Coastal Access Modification Report IOS-MR1

Proposed changes to the submitted King Charles III England Coast Path proposals for IOS 3: Oak Lane, Minster to Hens Brook, Eastchurch

Location affected: Hens Brook, Eastchurch, Isle of Sheppey

Natural England's Modification Report to the Secretary of State

Map MR1A - Modifications - Hens Brook

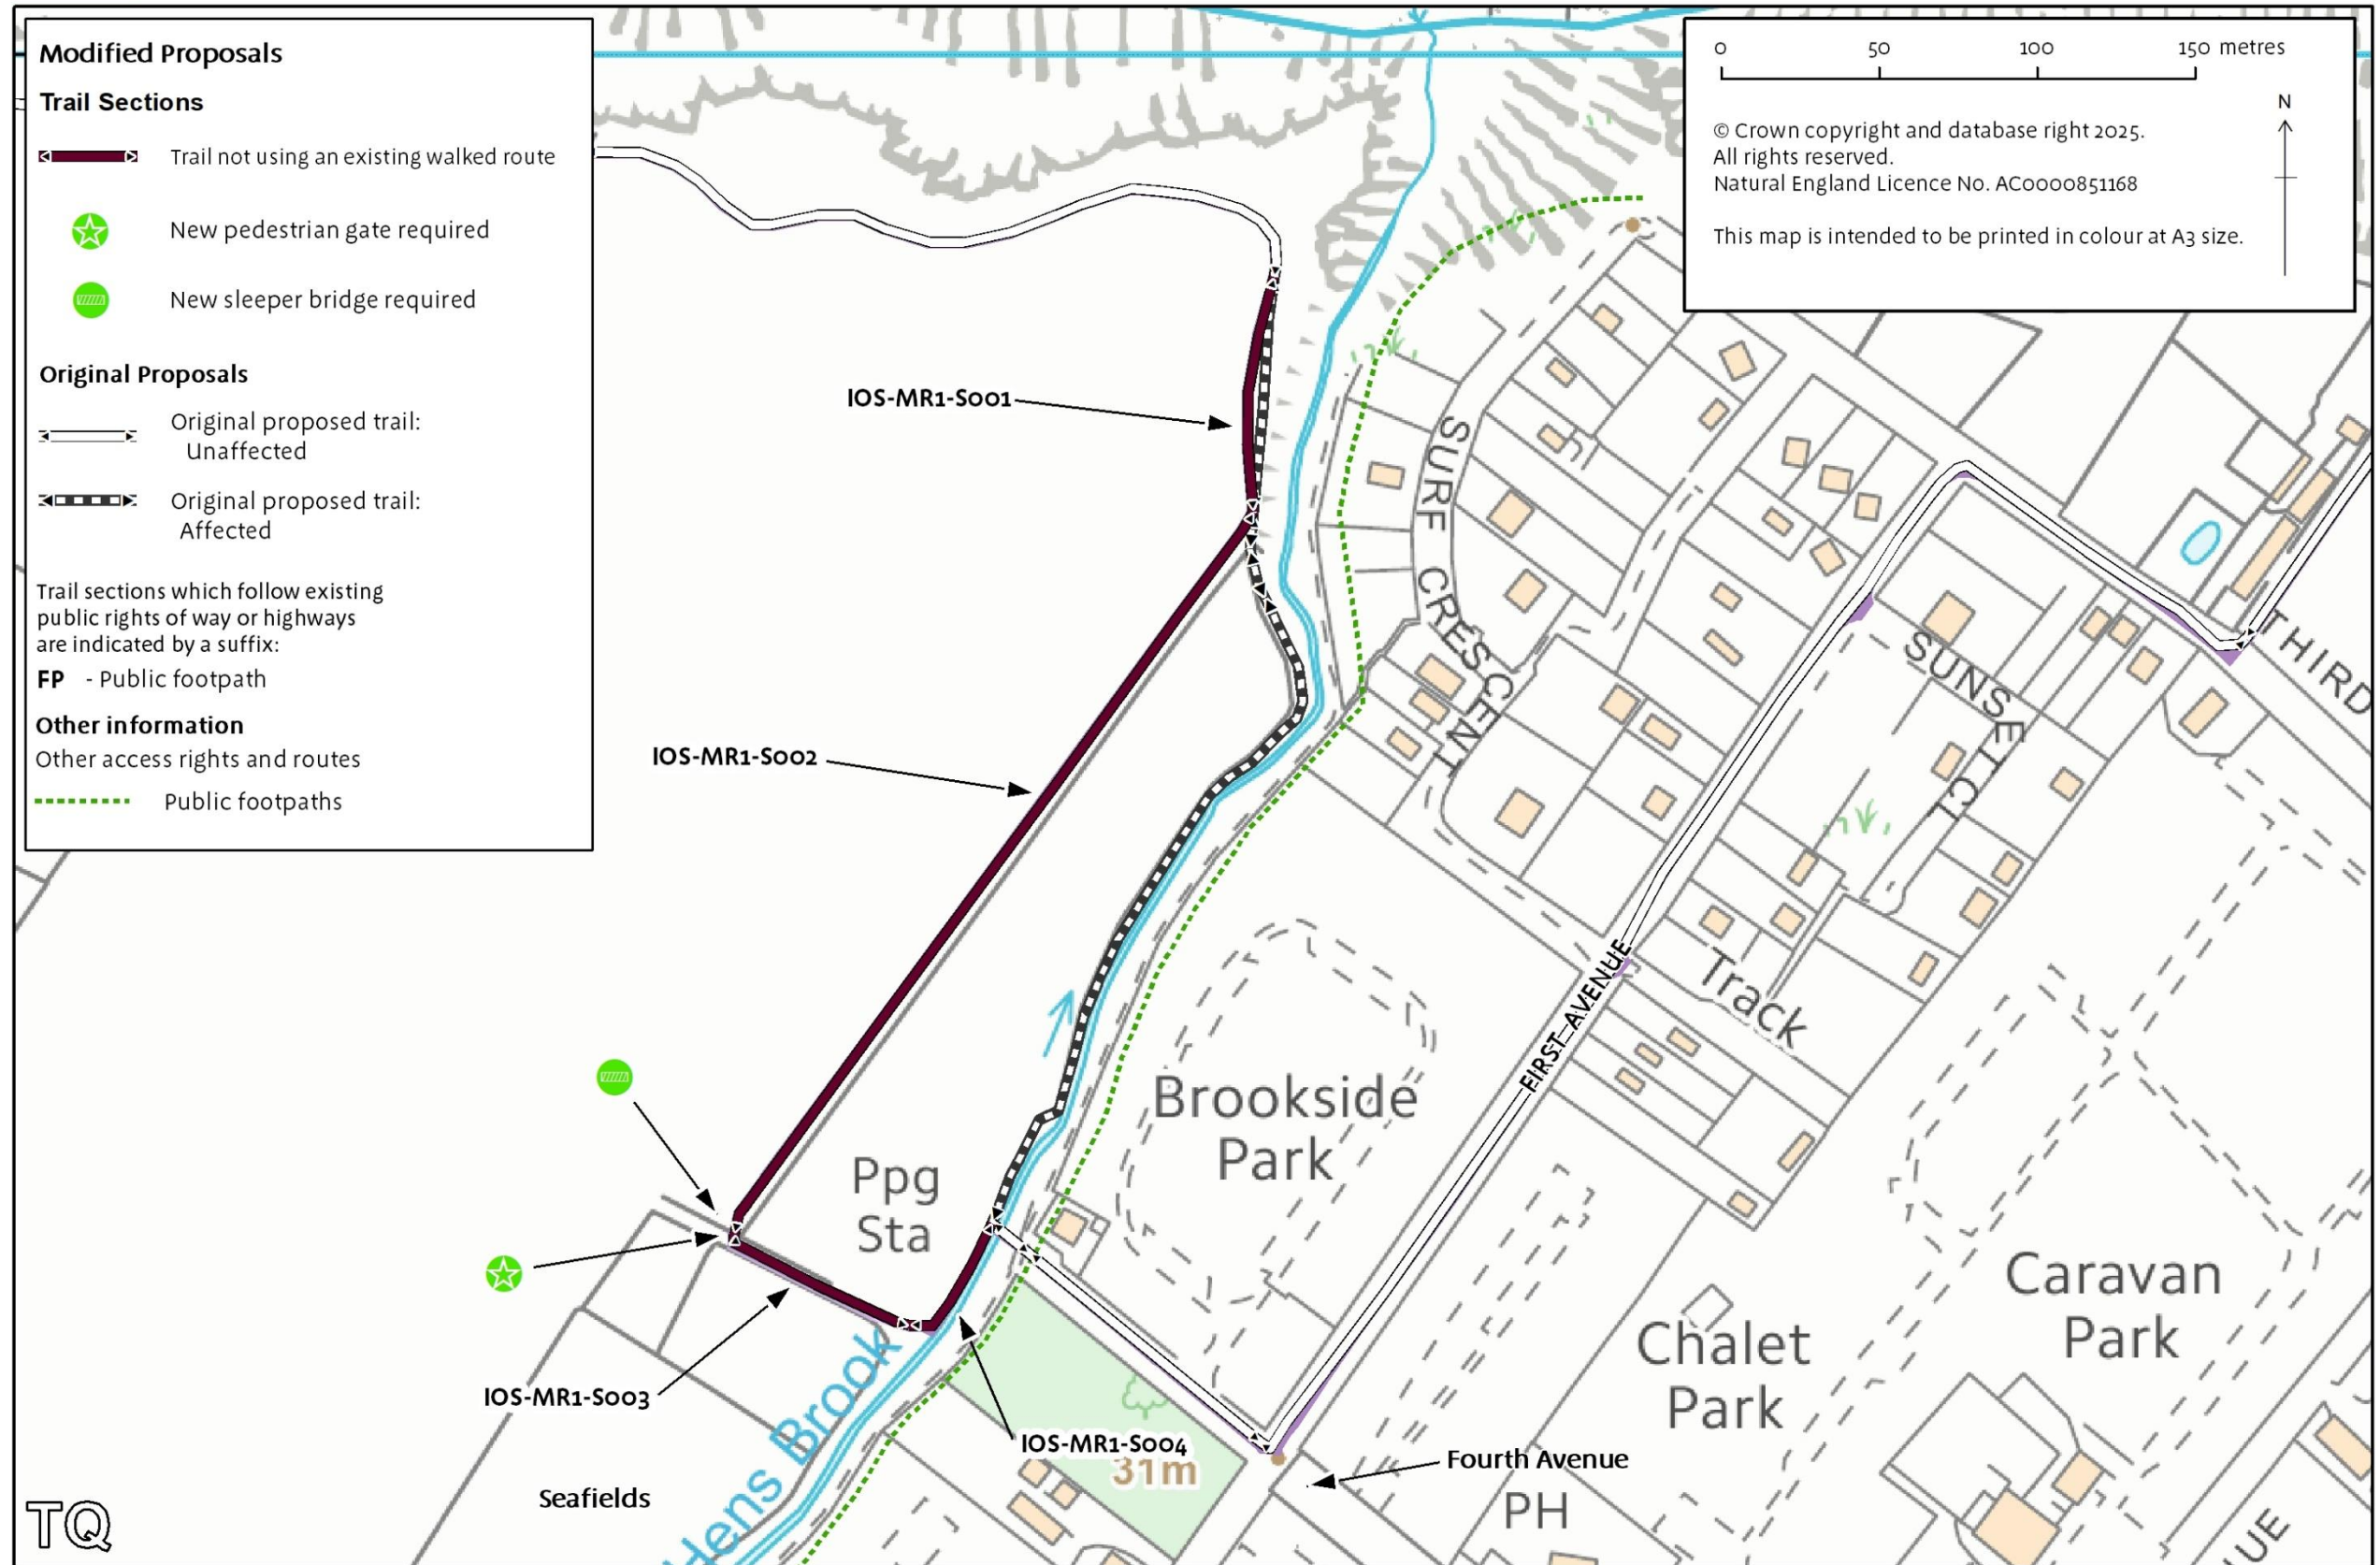
A.1.2 Following review of aerial photographs, we identified that a landslip had occurred on the edge of an arable field that would have a minor effect on the proposed alignment.

In addition, at a site visit post submission, a landowner highlighted significant new safety concerns regarding the proposed mix of walkers and horses along the grassy track on the western bank of Hens Brook. These concerns were not brought to our attention during the development of our initial proposals.

The narrow space, lack of visibility along the track and temperament of the stable's current horses could pose safety concerns in a shared space. By re-routing the proposed trail, walkers and horses will not be confined together in this space.

A.2.1 Our proposal (see map MR1A) is, from west to east, to re-route the path shown as sections IOS-3-S019, and sections IOS-3-S020 to IOS-3-S021 in our original report.

- The new section of trail to avoid the landslip is 75 metres in length at a maximum of 7 metres landward of the original route proposed. Our modified route follows the new edge of the arable field beside Hens Brook.
- The new section of trail to avoid the brookside track is 376 metres in length at a maximum of 62 metres westward of the original route proposed. Our modified route follows the eastern boundary of an arable field; through a new gap in a hedgerow; through an open area between horse paddocks (section IOS-MR1-S003); north-east along a short stretch of grassed track, to end by an existing bridge across Hens Brook.

MR1B - Modifications - Hens Brook - Directions

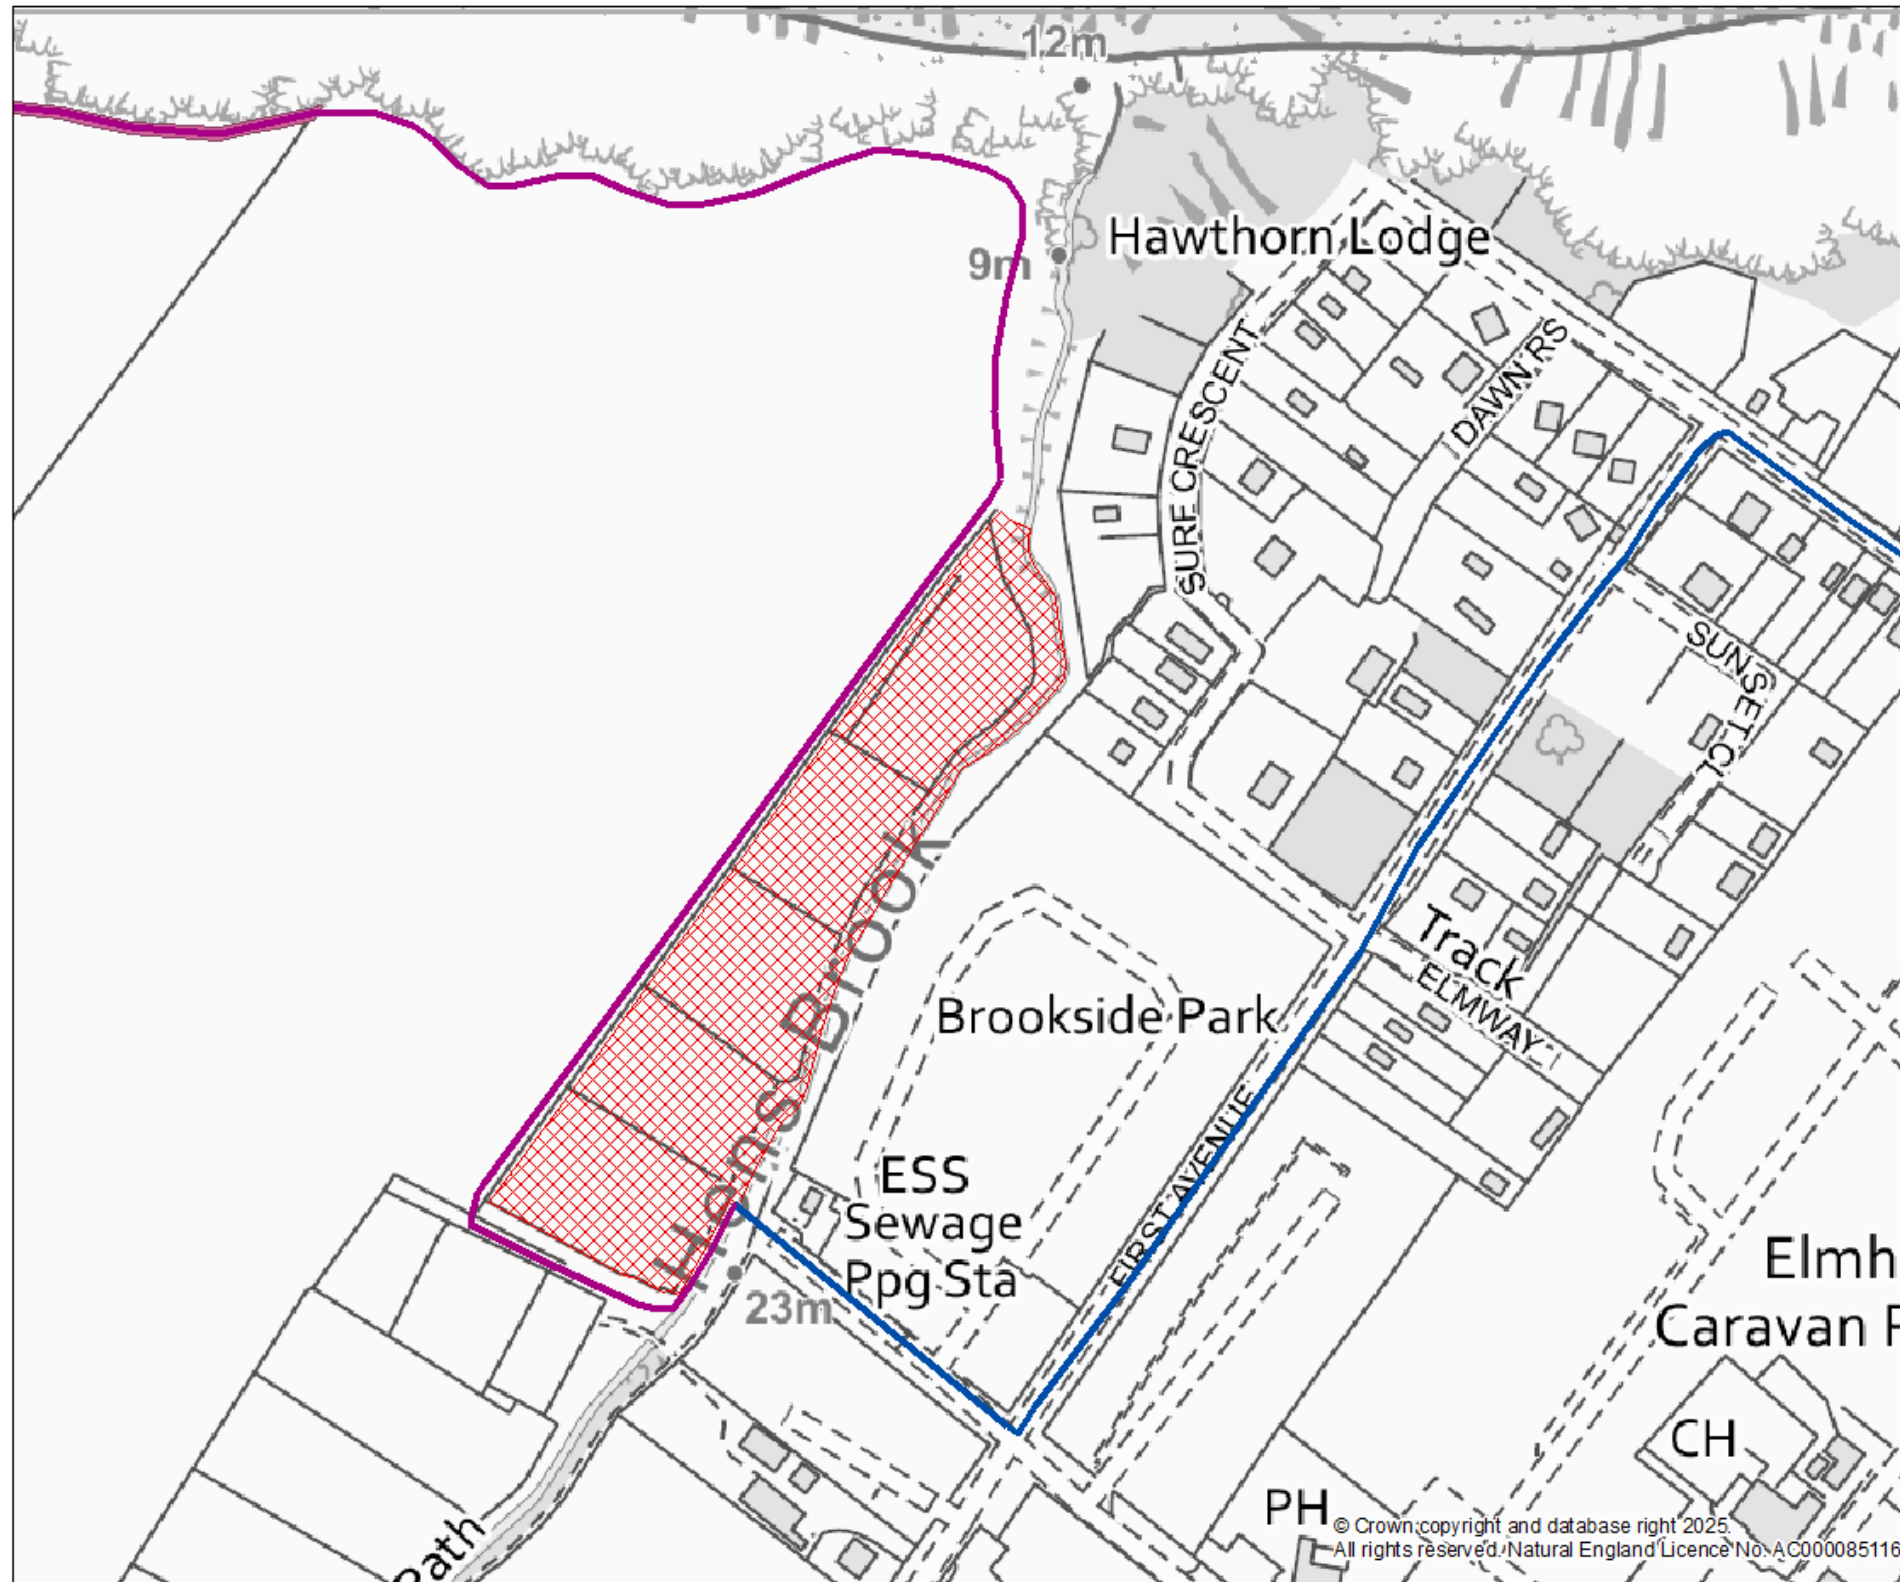
A.2.5 Coastal Margin: Access to the coastal margin will be excluded all year round to the horse paddocks and brook-side track adjacent to Brookside Park, seaward of route sections IOS-MR1-S003 and IOS-MR1-S004. This is proposed under Section 25(1)(b) of the Countryside and Rights of Way Act (2000) for the purpose of public safety. This exclusion will not affect the route itself.

The temperament of the horses in the paddocks adjacent to Brookside Park is unpredictable, and the individual paddocks where the horses are kept are quite confined with limited points of access onto the brook-side track. It is unlikely that horses and access users can avoid each other on the track or within these small compartments. To protect access users from possible conflict with the horses we are proposing to exclude coastal access rights all year.

A.2.6 Trail: Access to the King Charles III England Coast path route will be restricted for walkers with dogs - to keep dogs on leads at all times along route sections IOS-MR1-S001 to IOS-MR1-S004.
